February 23, 2021

Re: Comment Response Letter:
Coke Point Area – Corrective Measures
Study Investigation Report
Area B: Parcels B10, B11, and B12
Tradepoint Atlantic
Sparrows Point, MD 21219

**Figure
1**

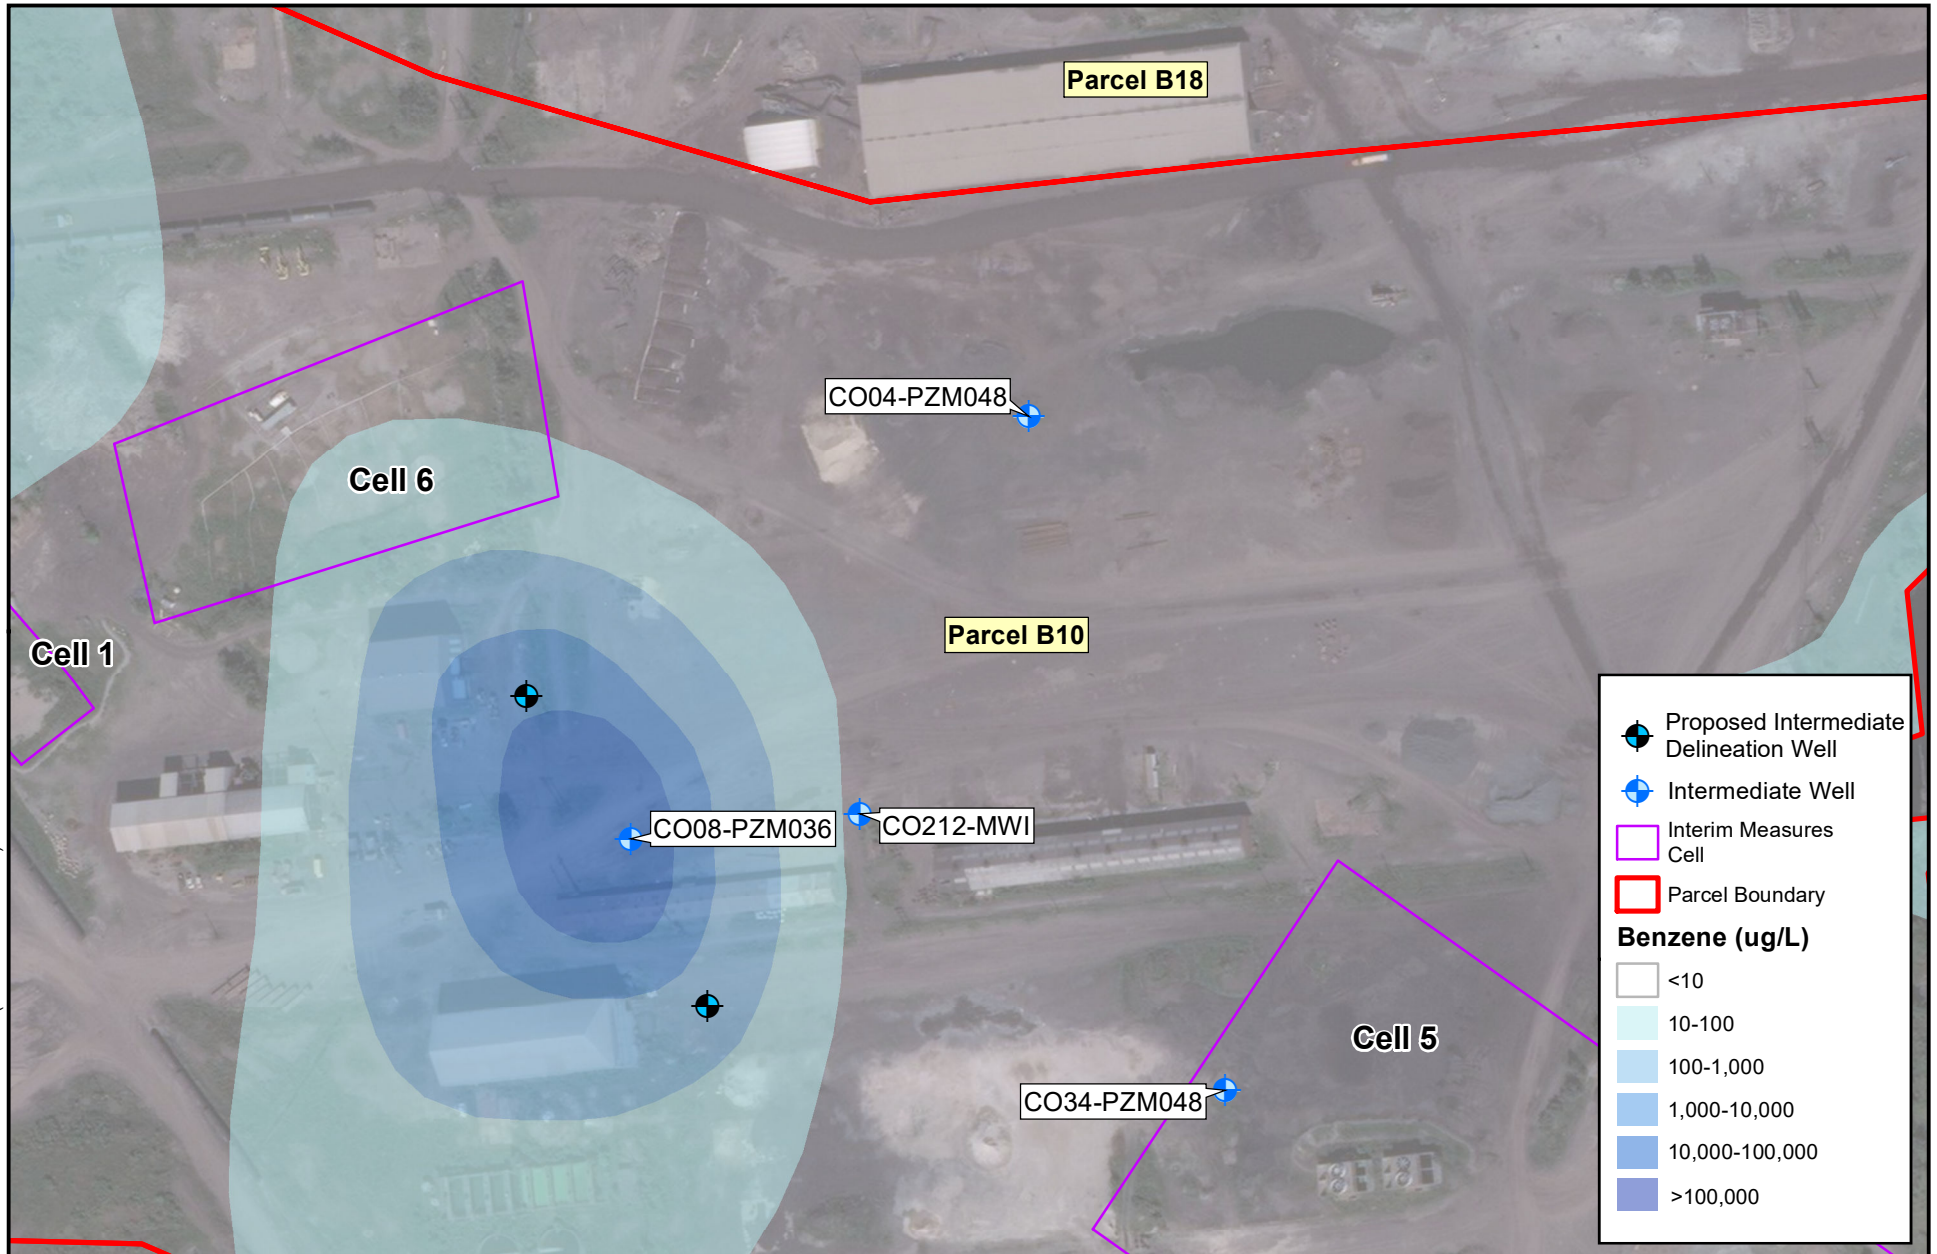
3. *EPA's comments 4, 5, and 6 all indicated the need for additional source delineation/evaluation to determine if additional source control actions would be needed related to contamination found at wells CO05, CO08, and CO212. The responses agree that the sources cannot be confirmed, but do not propose any specific action in the CMS to address the issue. The CMS should address uncertainty related to the adequacy of source delineation, either by additional source delineation in the CMS or as part of remedy implementation.*

Additional groundwater delineation will be conducted around wells CO05-PZM006, CO08-PZM005, and CO212-MWS in order to determine if additional source control action would be necessary. This letter proposes installation and sampling of seven shallow zone piezometers and two intermediate zone piezometers as shown on the attached **Figure 1** and **Figure 2**. Samples will be analyzed for VOCs and PAHs.
